# Addendum No. 02

## Campus Security Improvement Phase 1

**PREPARED BY:** PBK Architects, Inc.  
7790 N. Palm Avenue  
Fresno, California 93711

**PBK PROJECT NO.:** S2100500AR  
**DSA FILE NO.:** N/A  
**DSA APPLICATION NO.:** N/A

**SITE PLAN**

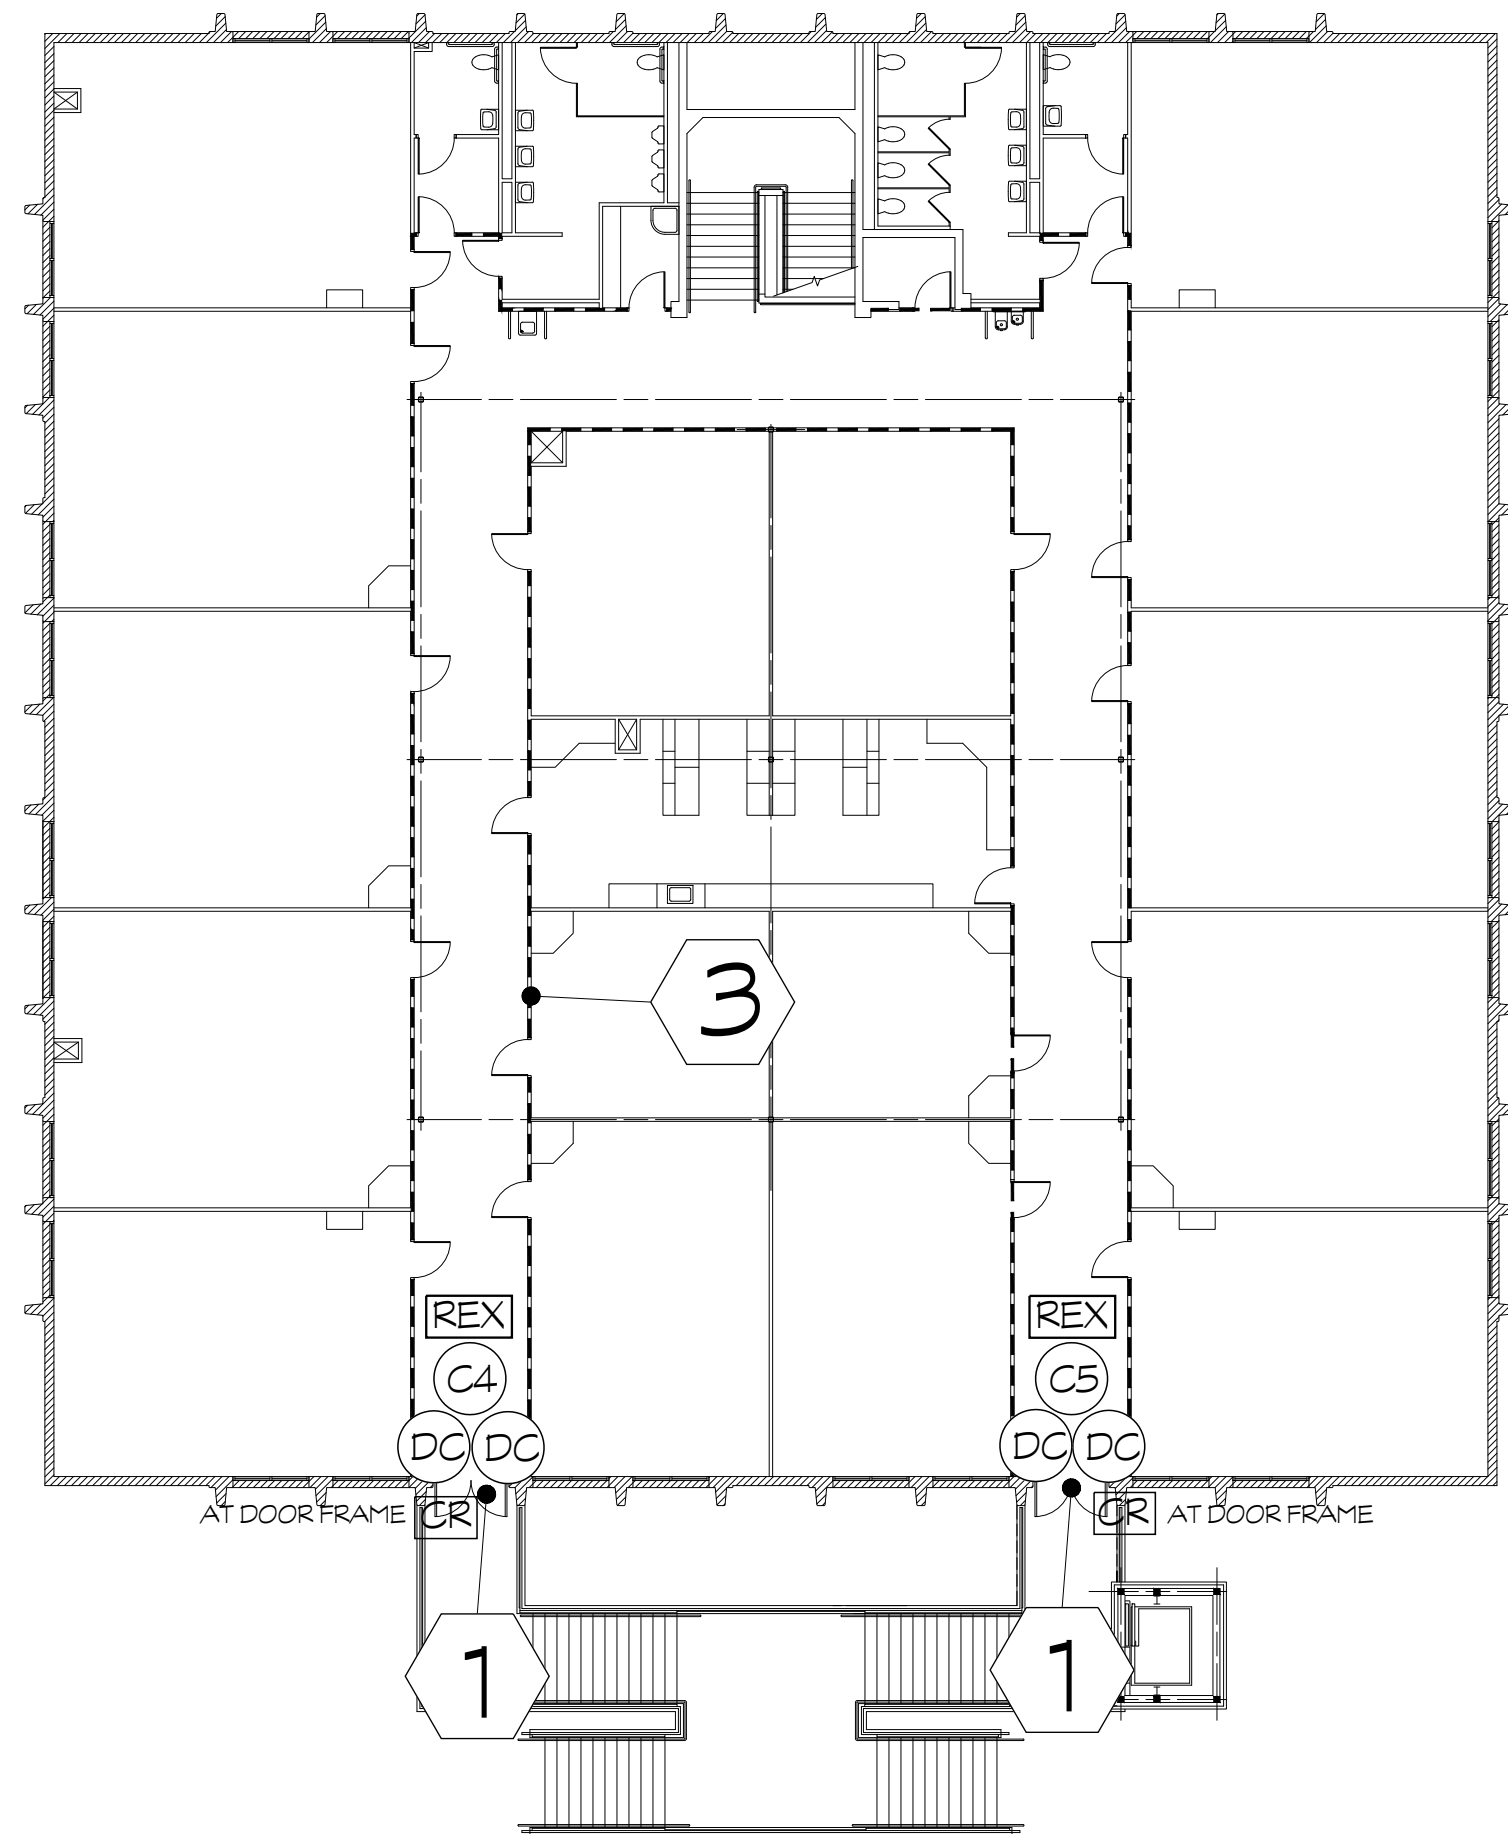
- 2-01 Sheet A1.0 – SITE PLAN**, revise as follows:  
Add Sheet A1.0. See attached.
- 2-02 Sheet A4.0 – CLASSROOM WING (BUILDING C)**, revise as follows:  
Revise Keynote 3 to Keynote 4. See attached.
- 2-03 Sheet A5.0 – CLASSROOM WING (BUILDING D)**, revise as follows:  
AC symbol add note. "AC IN ATTIC SPACE". See attached.
- 2-04 Sheet A5.1 – REFLECTED CEILING PLAN (BUILDING D)**, revise as follows:  
AC symbol add note. "AC IN ATTIC SPACE". See attached.
- 2-05 Sheet A10.0 – LIBRARY WING (BUILDING B)**, revise as follows:  
AC symbol add note. "AC IN ATTIC SPACE". See attached.
- 2-06 Sheet A10.1 – REFLECTED CEILING PLAN (BUILDING B)**, revise as follows:  
AC symbol add note. "AC IN ATTIC SPACE". See attached.

**12 ACCESS CONTROL SYSTEM**  
SCALE: N.T.S.

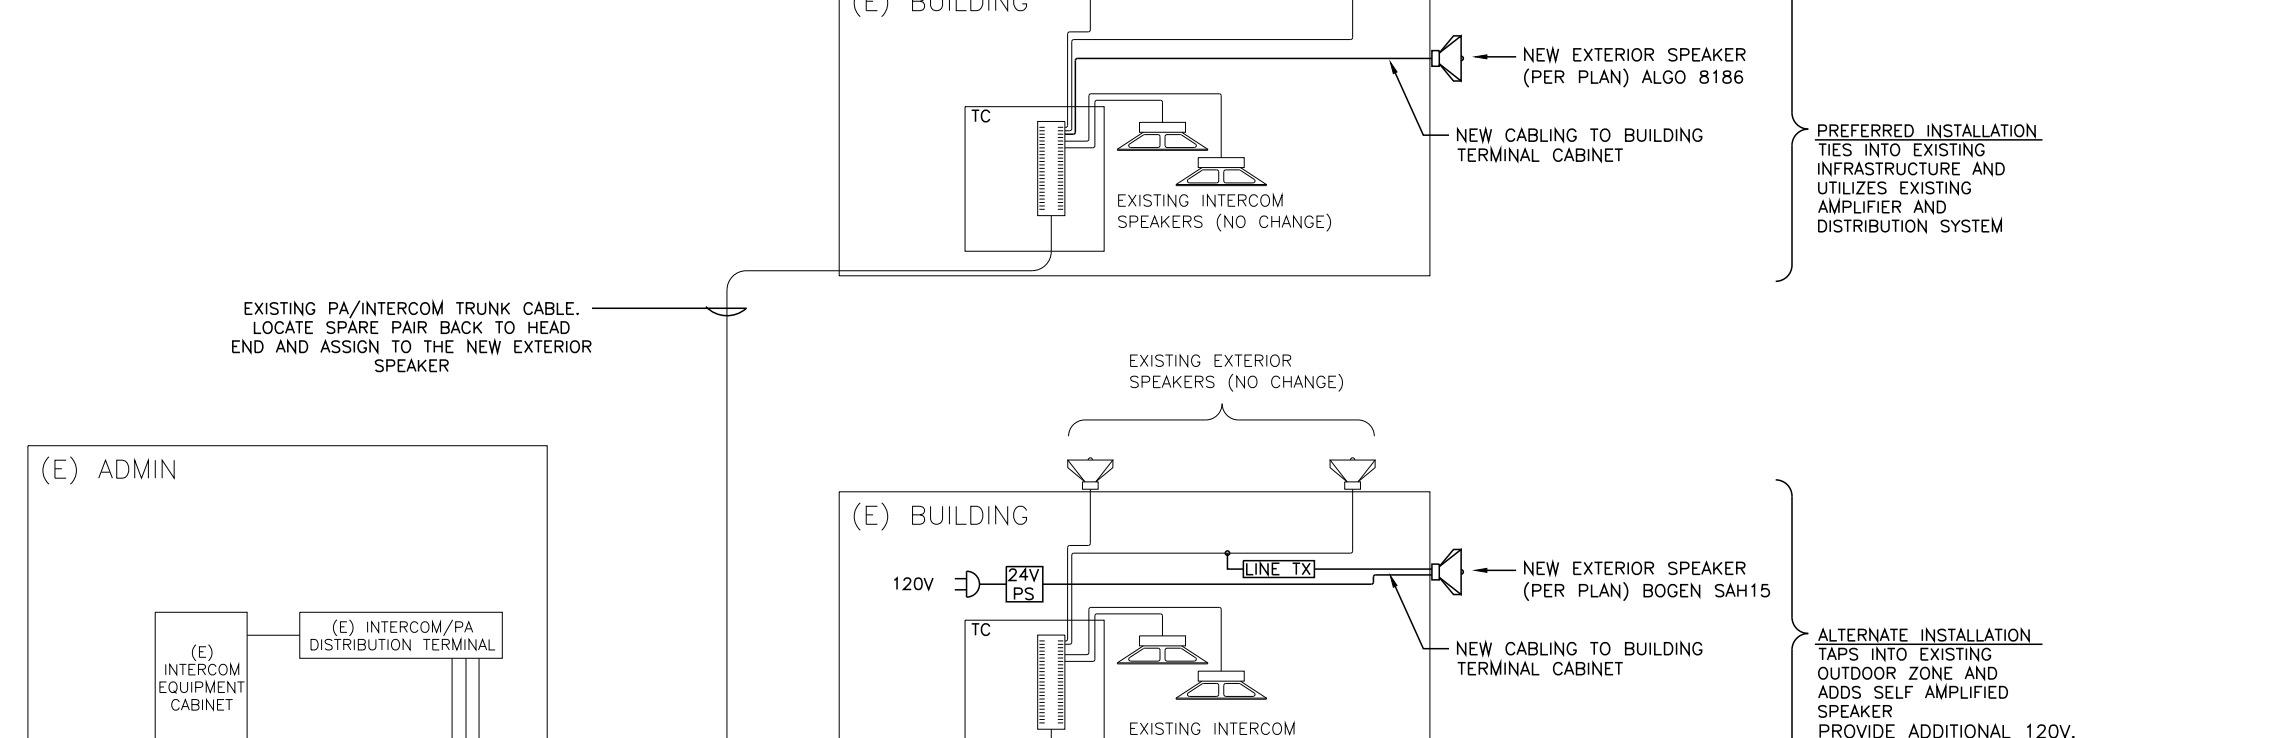
- 2-07 Sheet D1.1 – REVISED DETAIL 12**, revise as follows:  
Revised note see attached.

### 12 ACCESS CONTROL SYSTEM

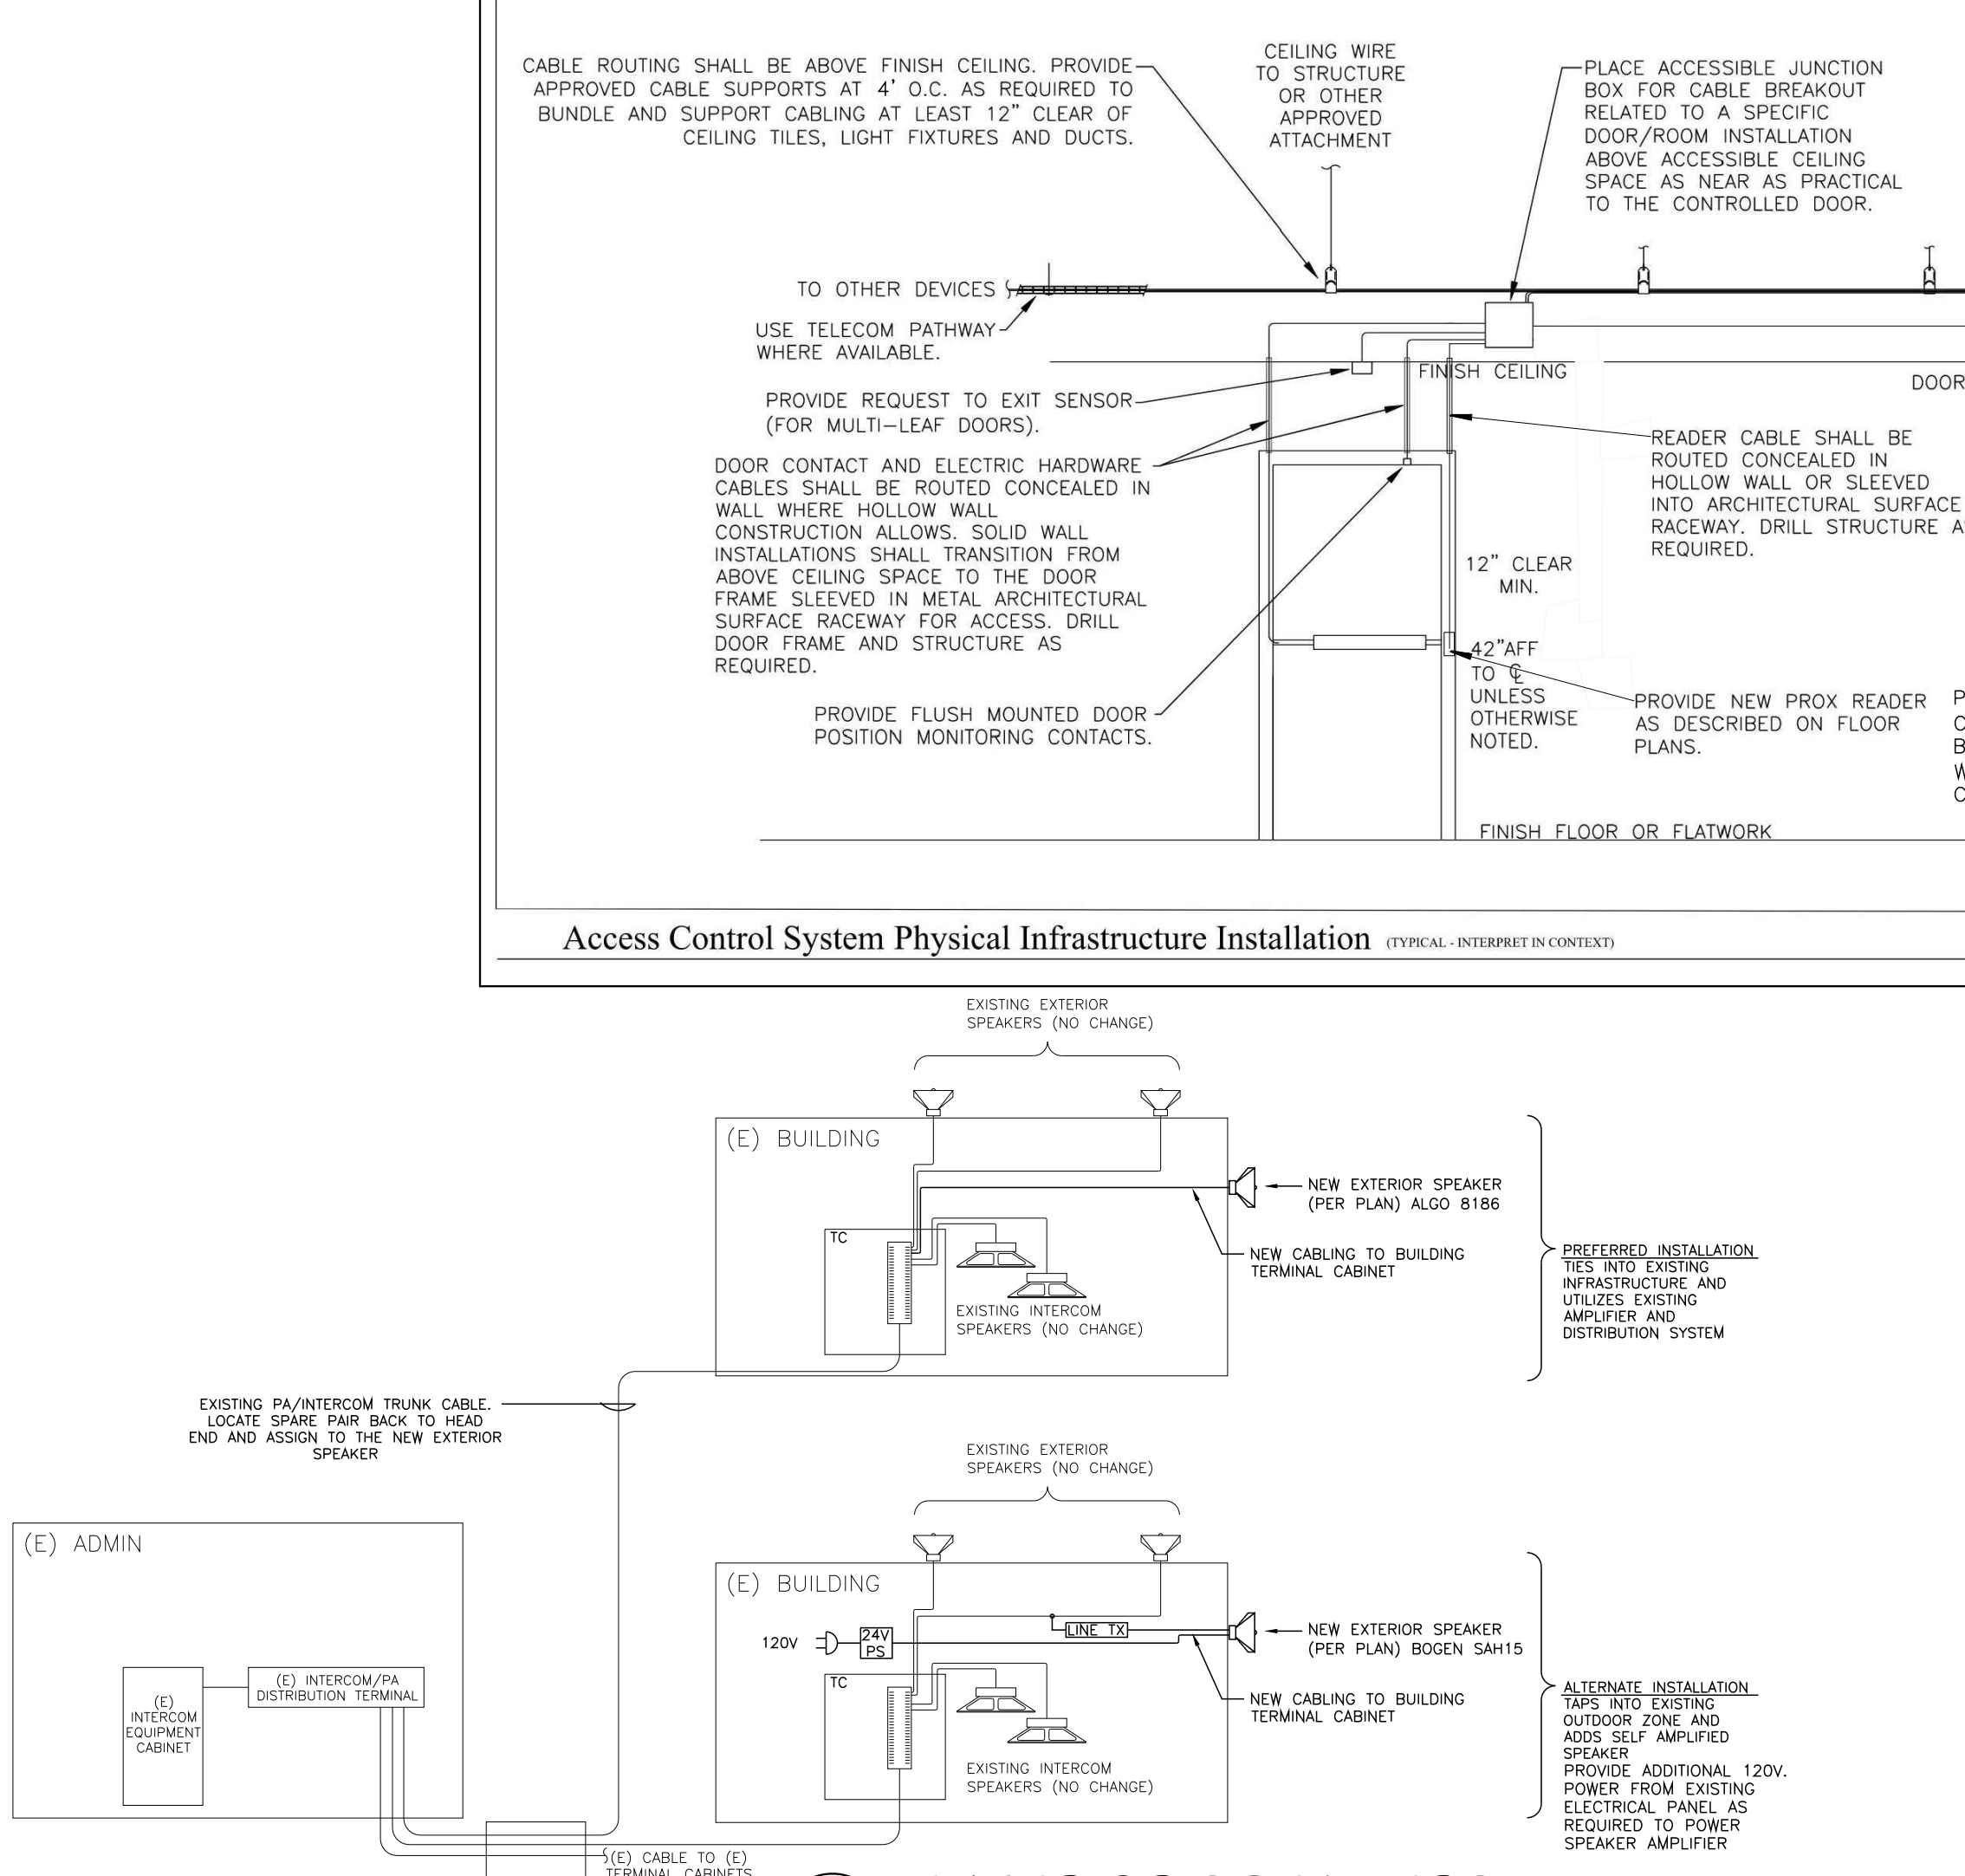
- 2-10 Sheet D1.1 – REVISED DETAIL 12**, revise as follows:  
Revised note see attached.
